Model: PRIPORT Platinum		Date: 05-Jul-06	No: M-C267-001
Modified Article: VC-20 COMPONENT PARTS		Prepared by: M. Kanomata	
From: Priport Service Planning Section			
Classification: ☐ Parts catalog correction ☐ Vendor change ☐ To meet standards ☐ To facilitate assembly ☐ To improve reliability () ☐ Part standardization ☒ Other ()			
Model Name: Ricoh DX3340/ DX3440C/ DX3240, Gestetner CP6146L/ DX3440/ CP6300C/ DX3240, Savin 3180DNP, Lanier LDD 120, nashuatec DX3440/ DX3240, RexRotary DX3440/ DX3240, Standard: SD360

Model: PRIPORT Platinum/Platinum P		Date: 27-Sep-06	No: M-C267-002
Modified Article: Parts Catalog Correction		Prepared by: K. Yamamoto	
From: Priport Service Planning Section			
Classification:	☒ Parts catalog correction ☐ Vendor change ☐ To meet standards ☐ To facilitate assembly ☐ To improve reliability () ☐ Part standardization ☐ Other ()		
Model Name: Platinum: Ricoh DX3340/DX3440C/DX3240, Gestetner CP6146/DX3440/CP6300C/DX3240, Savin 3180DNP, Lanier LDD120, RexRotary DX3440/DX3240, nashuatec DX3440/DX3240, Standard SD360 Platinum P (China only): Ricoh DX3440CP, Gestetner CP6300P

Model: PRIPORT Platinum/Platinum P		Date: 23-Oct-06	No: M-C267-003a
Modified Article:

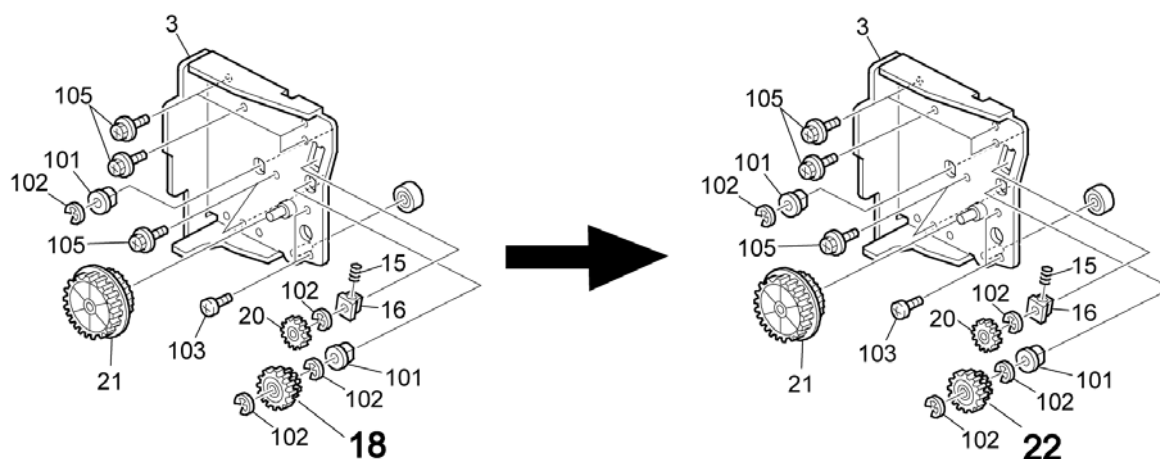
Change/Reason: The following index number was corrected and the part name was added.

Part Number	Description	Qty	Int	Page	Index	Note
C2313489	LOWER ROLLER GEAR	1	-	47	22

SYMPTOM

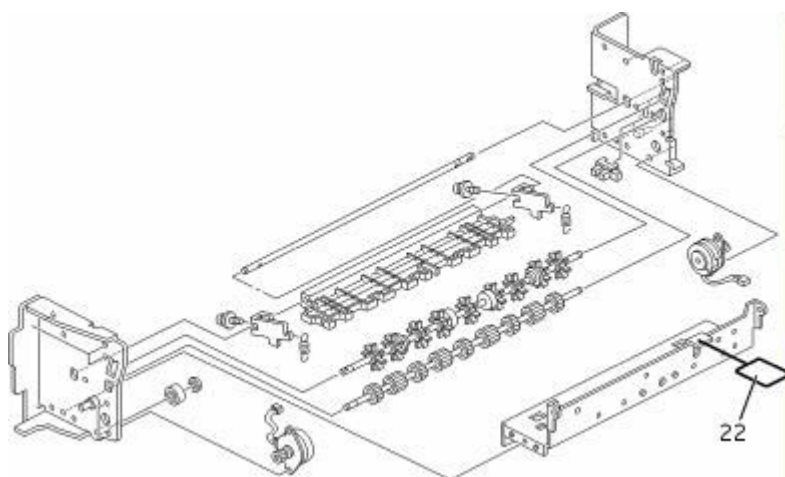
A master eject box set error occurs.

There is not much clearance between the master eject box and master eject unit, which causes the master eject box to come out of the master eject unit.

A Mylar was added at the base of the master eject unit to increase the clearance between the master eject unit and master eject box.

New #	Description	Qty	Page	Index
C2673473	GUIDE:MASTER EJECTION	1	47	22

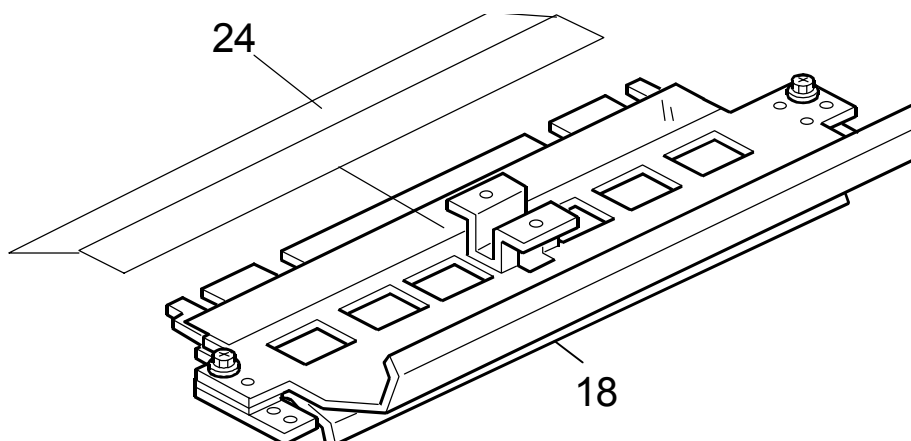
Change: The shape of the Paper Feed Guide Mylar was changed, and then added as a service part.

Reason: To further improve paper feed and minimize wrinkling.

Old #	New #	Description	Qty	Int	Page	Index
C2672891	C2672896	GUIDE PLATE:FEED ROLLER:ASS'Y	1	X/O	25	18
	C2672897	Paper Feed Guide Mylar	1	-	25	*24

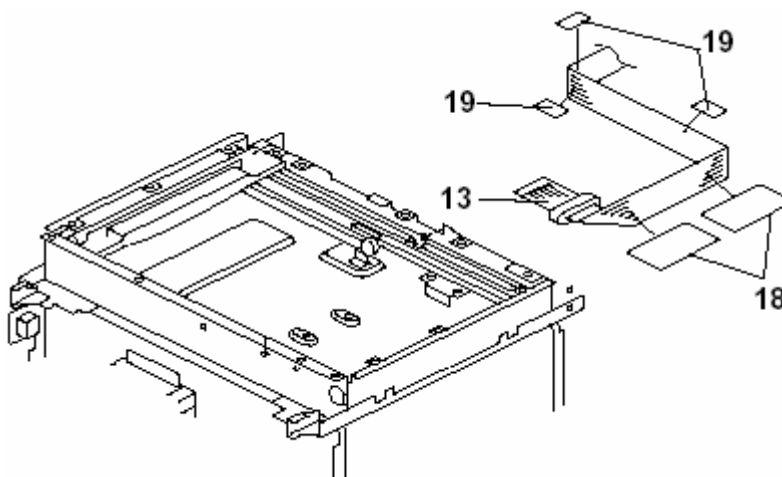
Change/Reason: The following index numbers were corrected.

Old #	New #	Description	Qty	Int	Page	Index
C2671804	C2675030	HARNESS:SBU:ASS'Y	1	X/O as a set	13	13
	B0391829	FLAT CABLE SHEET	3		13	*19
	B1501840	SHEET:FLAT CABLE:35X70	2		13	*18

2. OPERATION PANEL

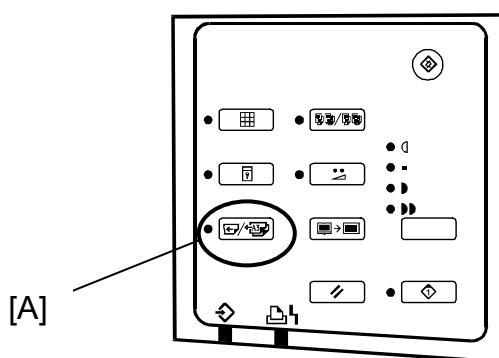
The [A] is changed

Sec	Page	Index	Parts No.	Description	Q'ty	MB No.
2	11	*	C2711450	Operation: Panel: EXP: Ass'y	1	-
2	11	2	C2711485	Sheet: Operation: Sub: Left: Chinese	1	-
2	11	6	C2711474	Key top: Memory	1	-

6. PAPER TABLE SECTION

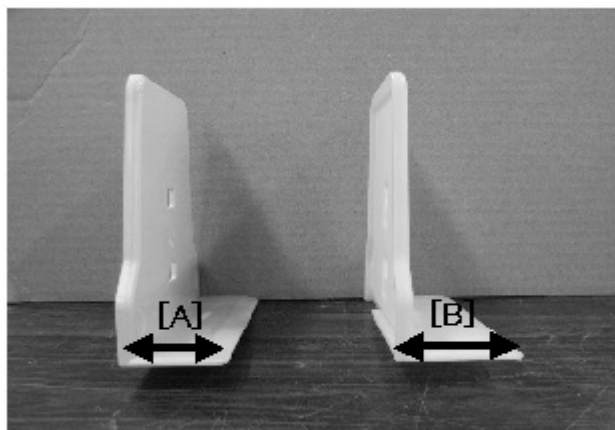
The length of side fence [B] (40.5mm) for Platinum2 is longer than [A] (32m) for PT.

Sec	Page	Index	Parts No.	Description	Q'ty	MB No.
3	19	18	C2672980	Side Fence: Paper Feed Tray	2	-
3	19	21	C2672710	Paper Feed Tray: CHN: Ass'y	1	-

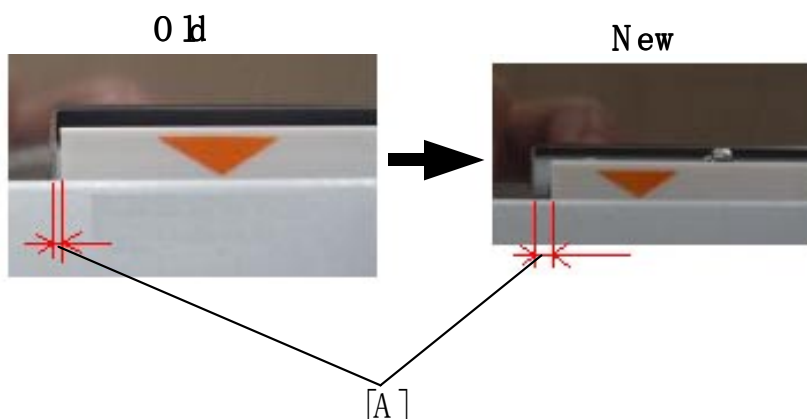
Change: The gap shown below [A] was widened (the size of the master set stopper was decreased).

Reason: To ensure that the master set stopper moves up properly into place.

Old #	New #	Description	Qty	Int	Page	Index
C2612055	C2612057	DISPLAY SUB-UNIT:LEADING EDGE:MASTER:PRINTING	1	X/O	31	7

1.EXTERIOR (C651)

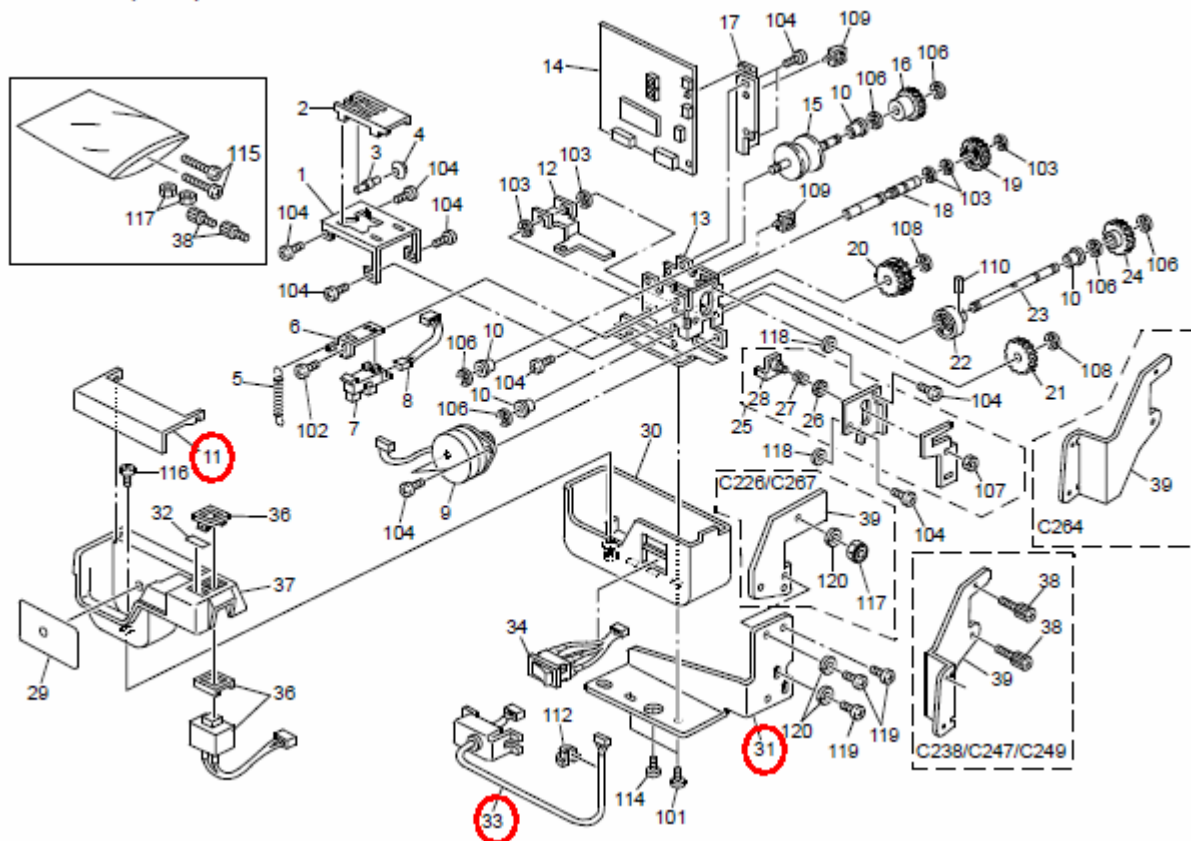
Change/Reason: Vendor change.

Old part number	New part number	Description	Q'ty	Int	Page	Index	Note
C6518230	C6518231	Harness: Coupling: Main: EXP	1	X/O	3	33	*C651-59 only
C5322205	C5322205	Tape Cover	1	O/O	3	11	
C5322111	C6512111	Tape Marker Bracket	1	X/O	3	31
